UNITED STATES PATENT AND TRADEMARK OFFICE

Office Action Summary	Application No.	Applicant(s)
	10/626,209	DEVOE, IRVING W.
	Examiner	Art Unit
	Krishnan S. Menon	1797

DETAILED ACTION

Figure 3

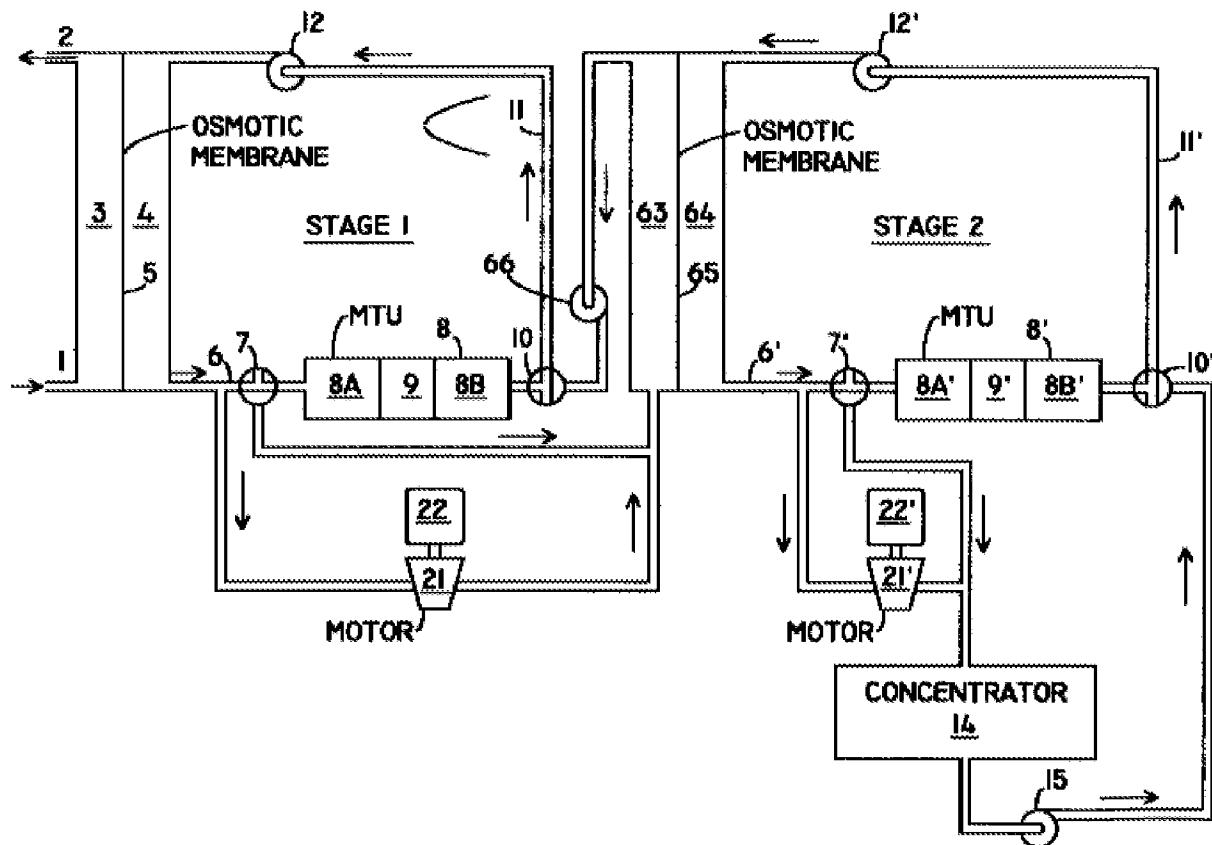
Prueitt fig 3 is reproduced below.

Osmotic membrane (65) separates two sealed chambers (63) and (64) in stage 2. The chambers are sealed because their inlets and outlets can be isolated by valves or other devices in the inlets and outlets. The solution chamber 64 has a solute solution which is diluted by fresh water from chamber 63 moving across membrane 65 by osmosis, which increases the solution pressure. This moves interface 9' to fill chamber 8A'. The turbine 21' also simultaneously produced energy.

Interface 9 or 9' is a piston or other movable interface (column 4, lines 1-2).

Concentrator 14 is the third chamber which evaporates water to concentrate the brine, which is recycled to chamber 64 via chamber 8B'. For more details of operation of the Prueitt system, see column 3, line 39 – column 4, line 41 and column 5, line 47 – column 6, line 34.

Pressure of the solute solution leaving the chamber 64 is high, and the pressure of the solution coming into 64 is low – see column 6, lines 15-25.

Pressure is applied and removed periodically to the piston 9' to extract work – it extracts work because its movement pumps concentrated solution from the concentrator to the solution chamber 64.

The turbine 21' is also a moving member, which extracts work.

Regarding the vacuum or low pressure in chambers 3 or 63 produced as water moves into the solution chamber through the membrane, the reference is silent on any vacuum produced, but vacuum or low pressure would be inherently produced as water moves from chambers 3 or 63 to 4 or 64 as is expected from the principles of osmosis, even though a complete vacuum is not possible because water would evaporate and create a vapor lock if the pressure drops below the vapor pressure of water. Such a vapor lock would stop the system from working.

Solvent chamber is being pressurized by a pump mechanism (8).

Recycling the solvent in the first chamber is taught by Prueitt – see stage 1 in Fig 3.
